CSP 26-006AL (BP030) – ADDENDUM No.01
Willowridge HS Renovations

Fort Bend Independent School District
2023 Bond Program

addendum

PROJECT BP030 Willowridge High School Fine Arts Addition and Renovation, 2023306
PROJECT NO. CSP 26-006AL
ADDENDUM NO. 001
BID PACKAGE ISSUE FOR BID AND PERMIT

SHEET NUMBER
A2.31

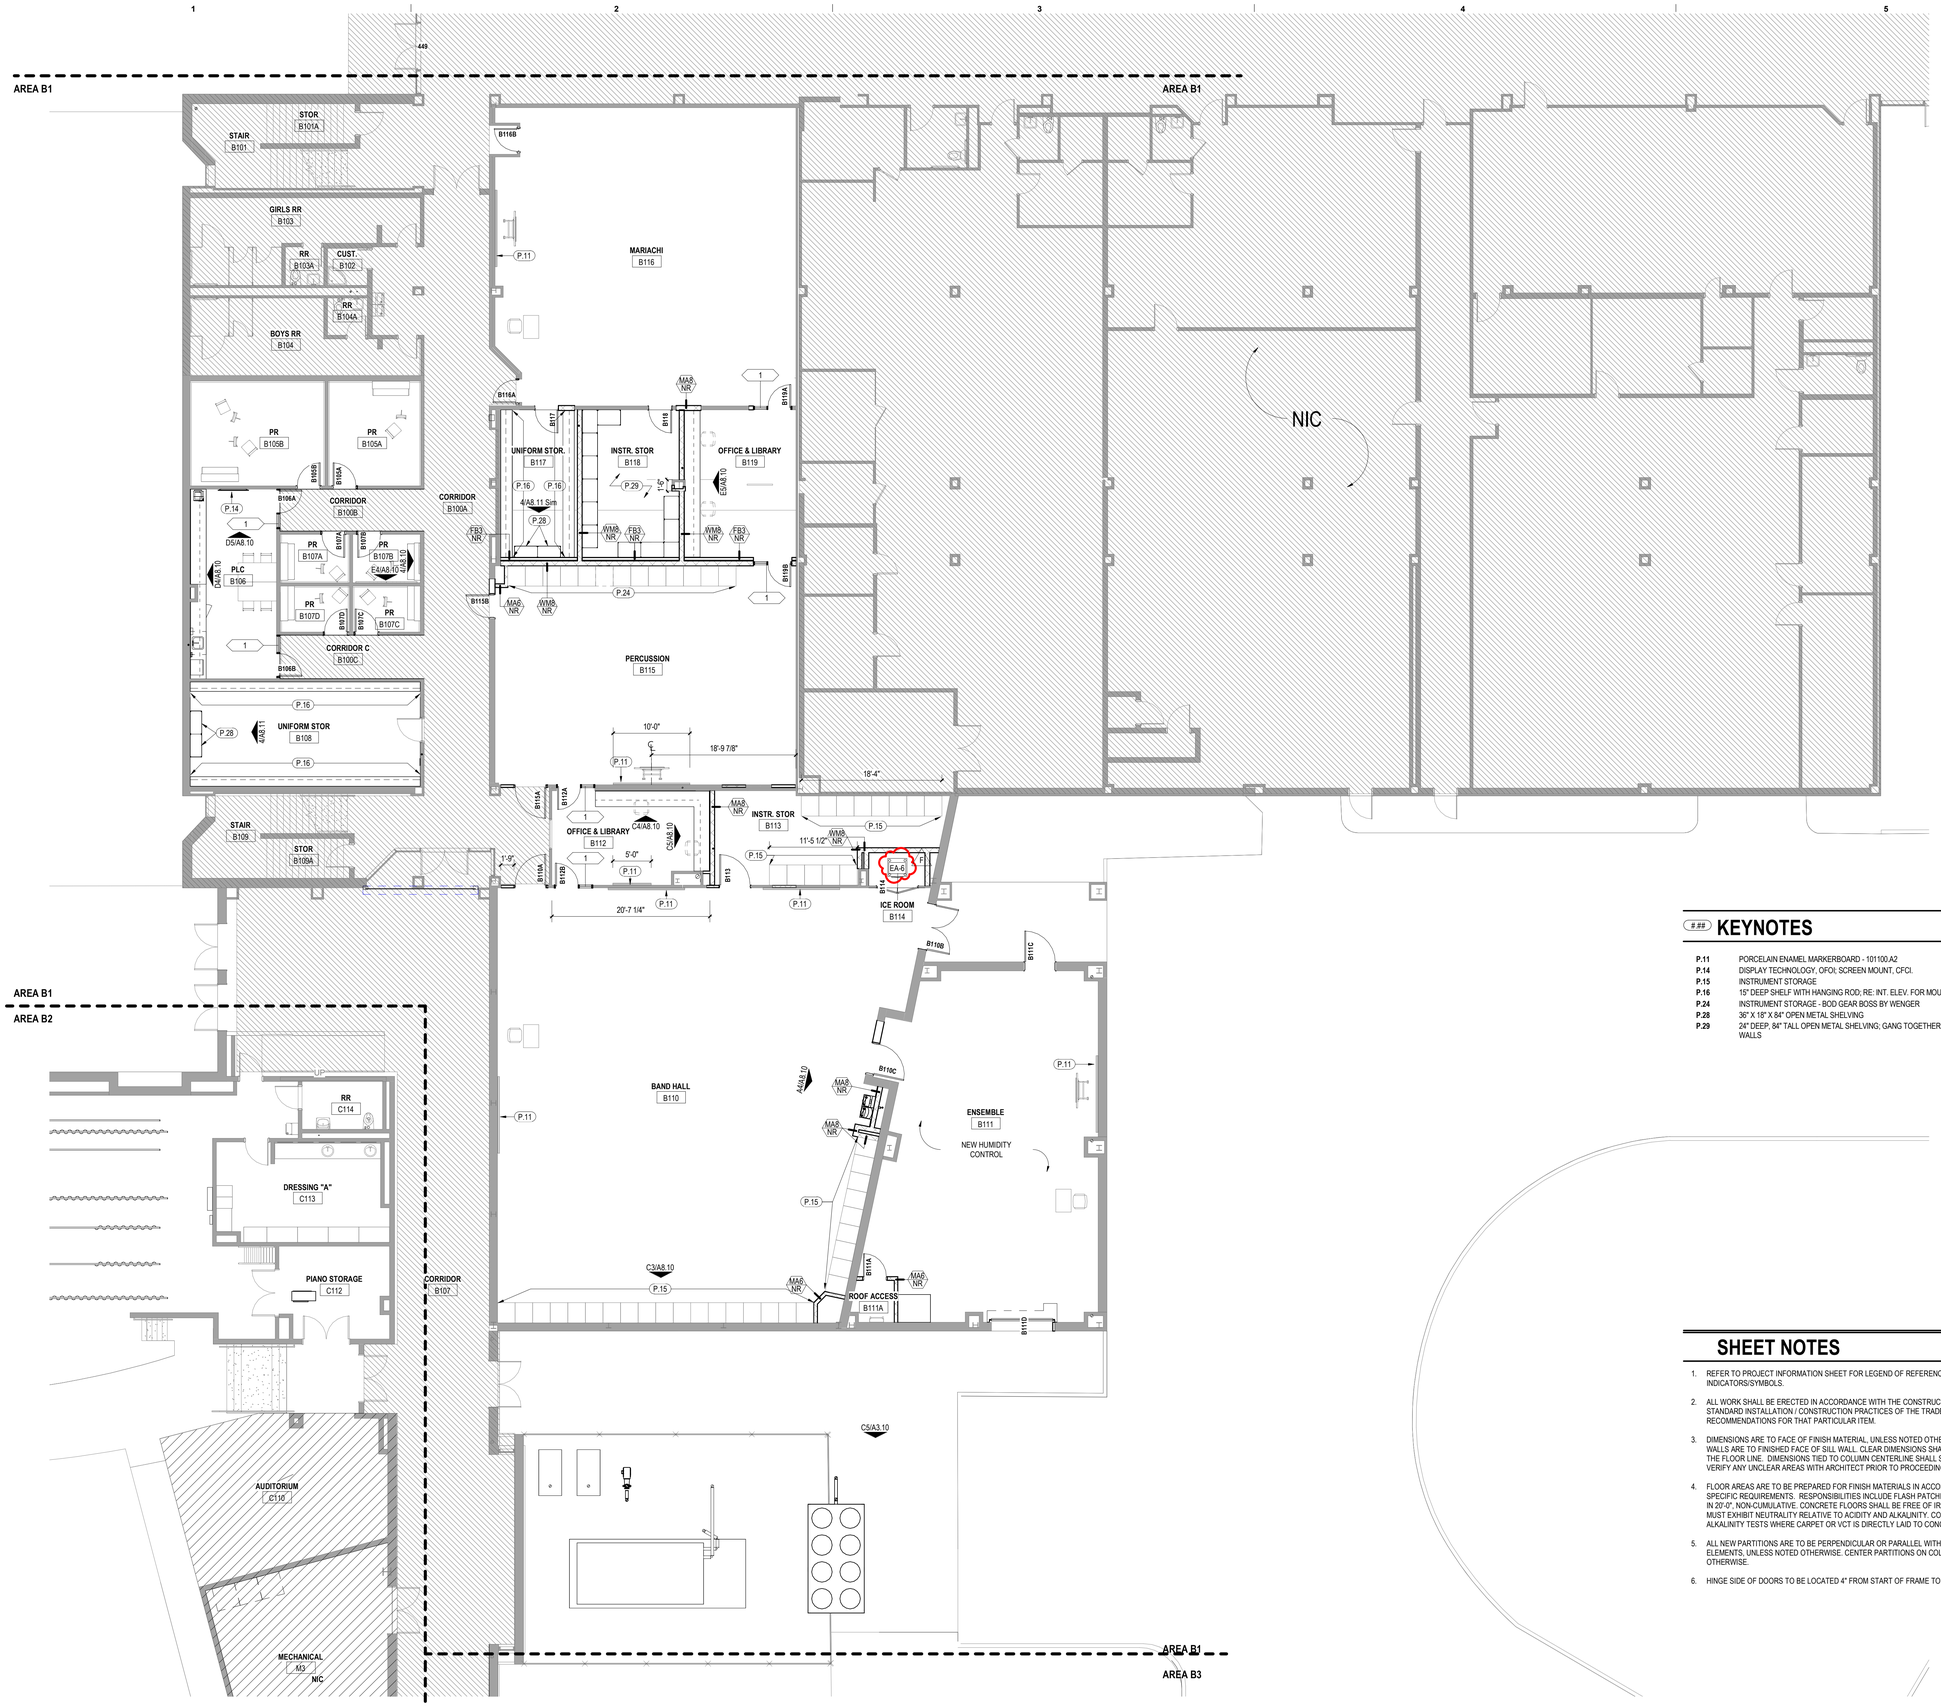
A2.31 - LEVEL 1 - FLOOR PLAN - AREA B1

1. Ice machine was missing from the ice room in the band hall. Equipment and tag has been added.

SHEET NUMBER
A2.32

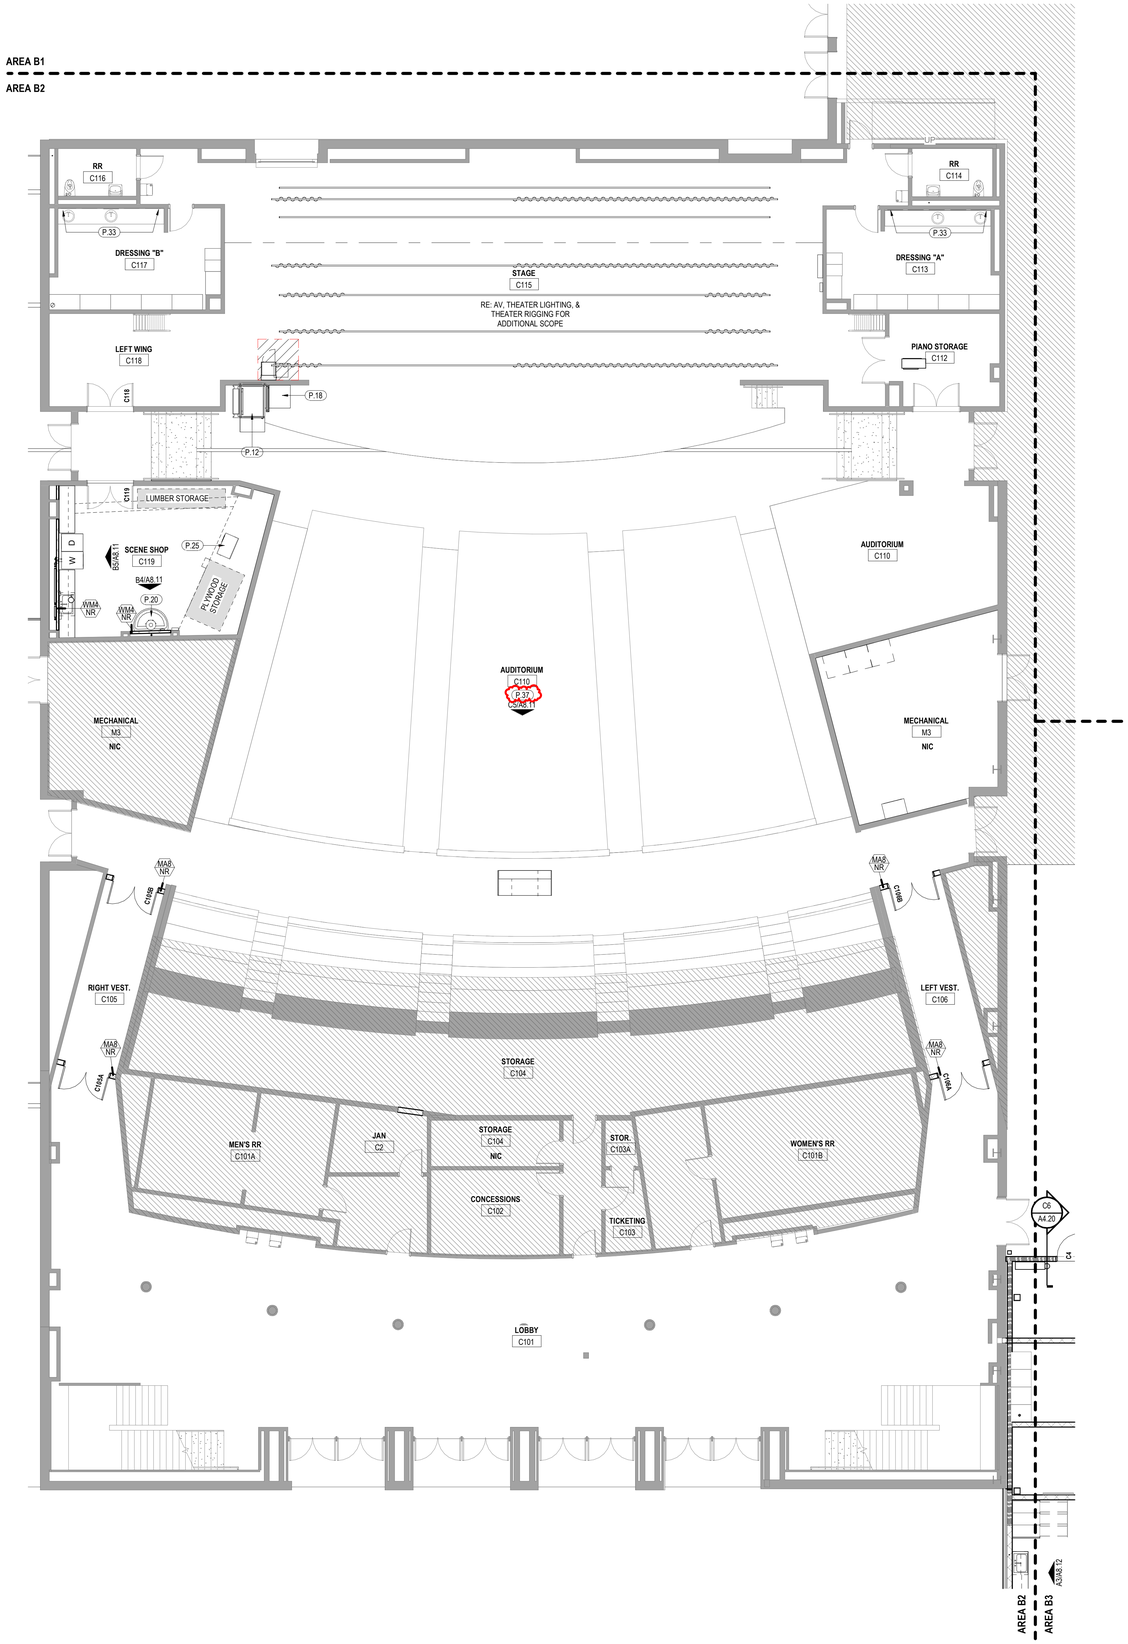
Q12 Drawing A2.32 - REUPHOLSTER (9) AUDITORIUM CHAIRS - Will an allowance be provided for the 9 chairs in the auditorium? No specification is provided. If so, what allowance value are the bidders to carry for this scope?
A12 There is no allowance value for this. The scope has been modified in the drawings for clarity.

A2.32 - LEVEL 1 - FLOOR PLAN - AREA B2

1. Updated the keynote for the auditorium chairs to clarify the scope

A2.70 - ENLARGED PLANS - ART ROOMS

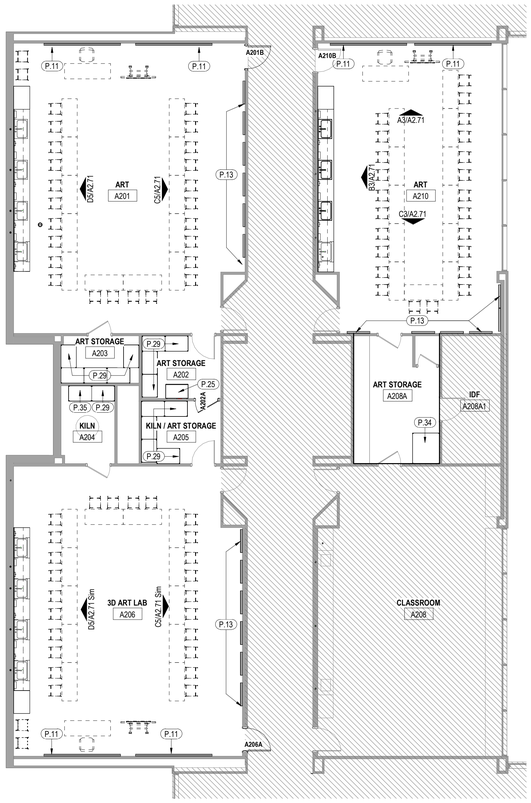
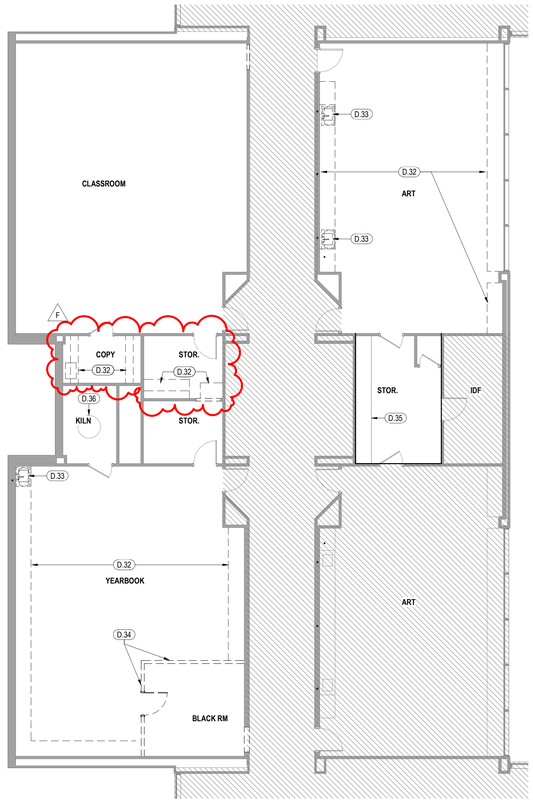
A9 There is scope in the Storage rooms where asbestos has been identified. The room that has the asbestos is labeled as the Copy Room on sheet A4/A2.70. The scope is to remove the casework in that room and include new finishes. Contractor to provide asbestos abatement prior to work being performed.

1. Demo plans updated to reflect existing conditions.

SHEET NUMBER
M2.14

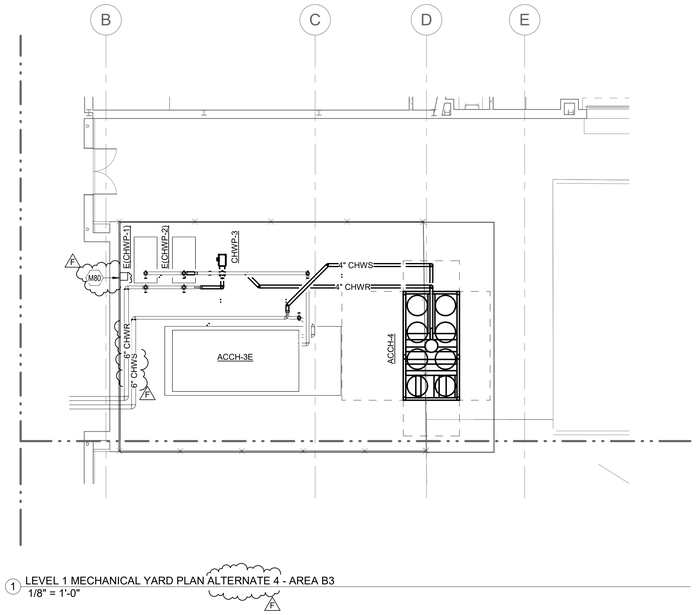
M2.14 LEVEL 1 MECHANICAL PLAN – MECH YARD

1. Adjusted piping sizes.
2. Added general notes
3. Added locations for new pump VFDs

SHEET NUMBER
M6.03
F

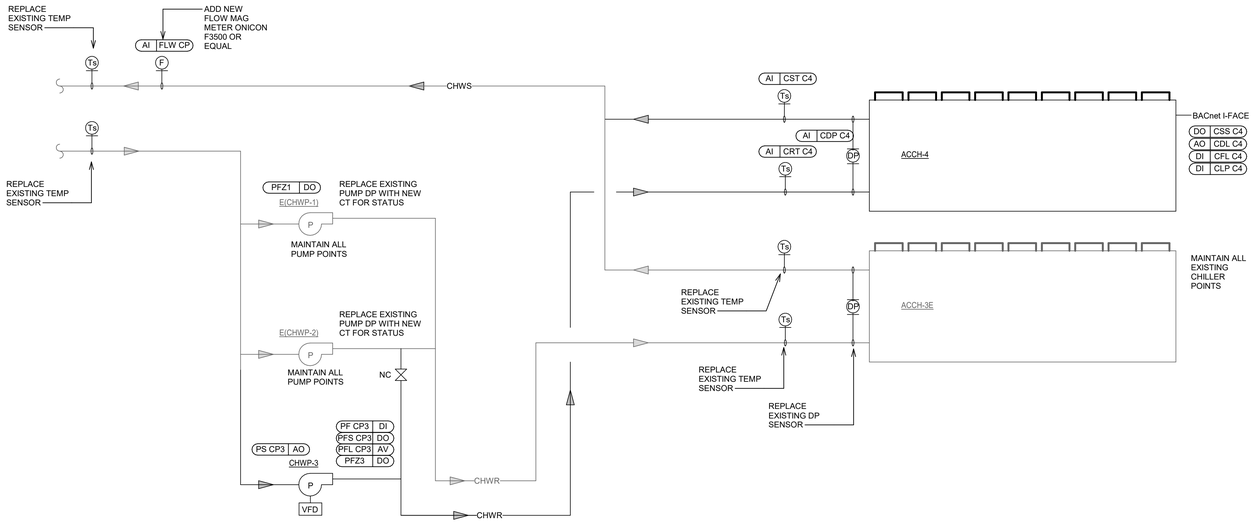
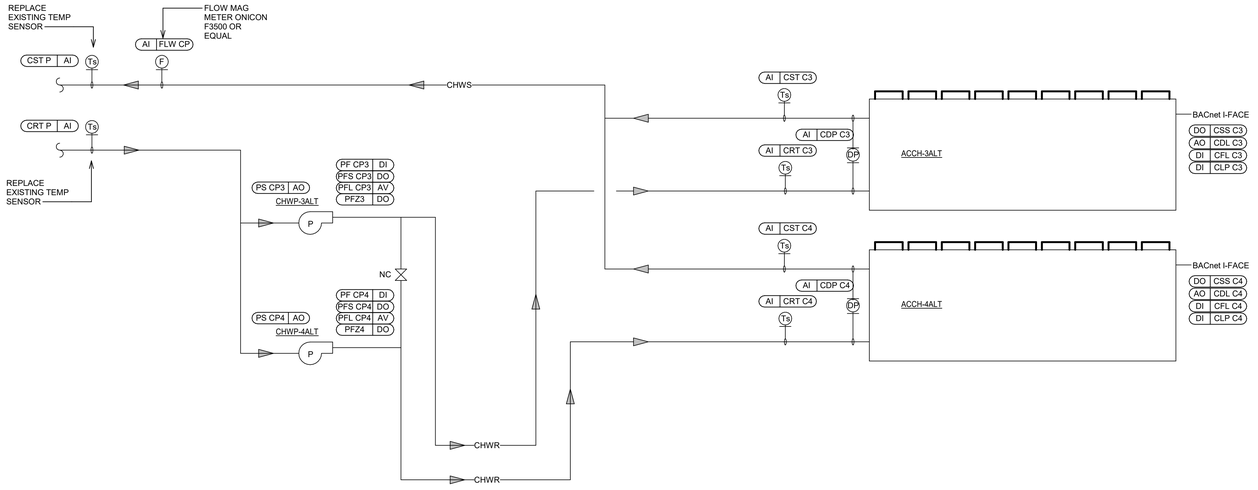
M6.03 MECHANICAL CONTROLS – FINE ARTS CENTRAL PLANT

1. Added sheet to project.
2. Added controls schematics and sequences of operations for chiller scope.

1 LEVEL 1 ELECTRICAL DEMOLITION FLOOR PLAN - AREA B1
1/8" = 1'-0"

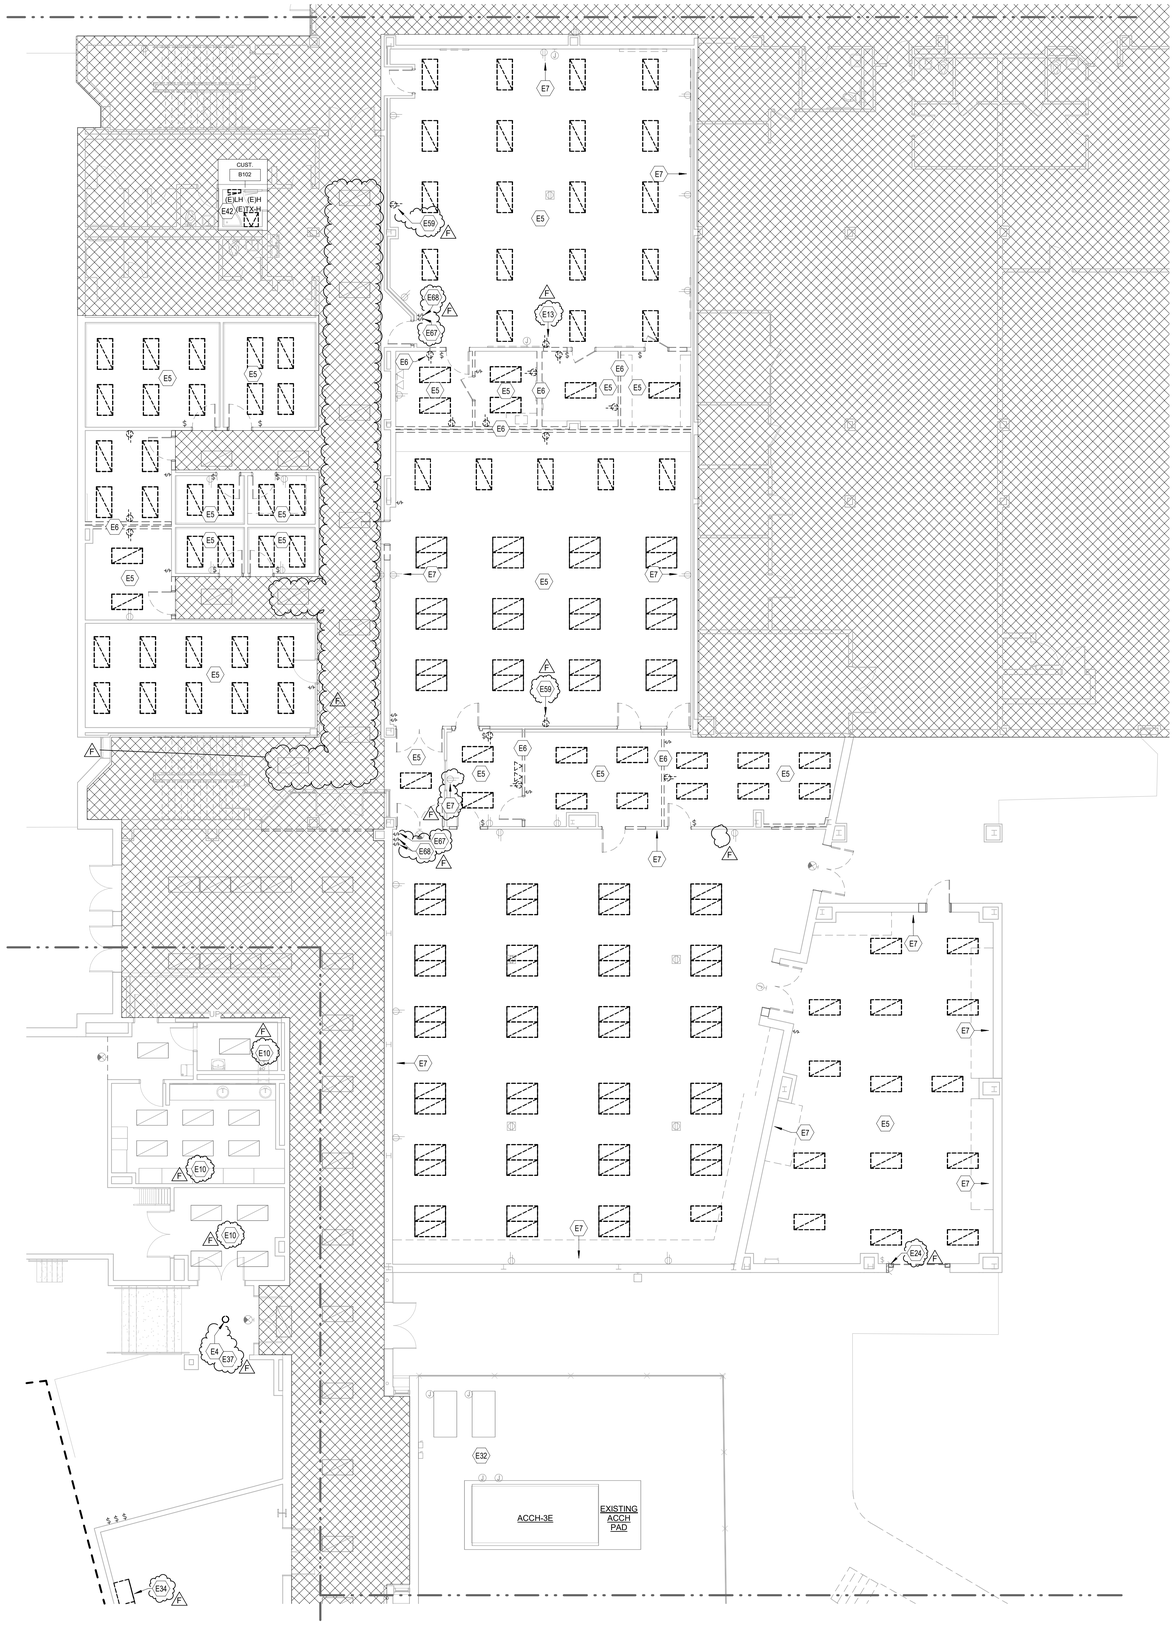
E2.13 LEVEL 1 ELECTRICAL DEMOLITION PLAN – AREA B1

1. Tagged note for overhead door revised from E23 to E24. Tagged note E23 removed from sheet.
2. Existing duplex revised from demolished to existing to remain. Tagged note E7 added.
3. View #3 renamed to 'ALTERNATE 5', and tagged note E33 modified to match.
4. Light fixtures not in scope region clarified to be existing to remain.
5. Added tagged notes E4, E34, and E37 added for theater area.
6. Removed duplicate duplex in Band Hall B110.
7. Added tagged note E13 to fixture marked for demo.
8. Added tagged note E59 to clarify receptacles to be removed and replaced.
9. Added tagged notes E67 and E68 to existing light switches in Mariachi B116 and Band Hall B110.
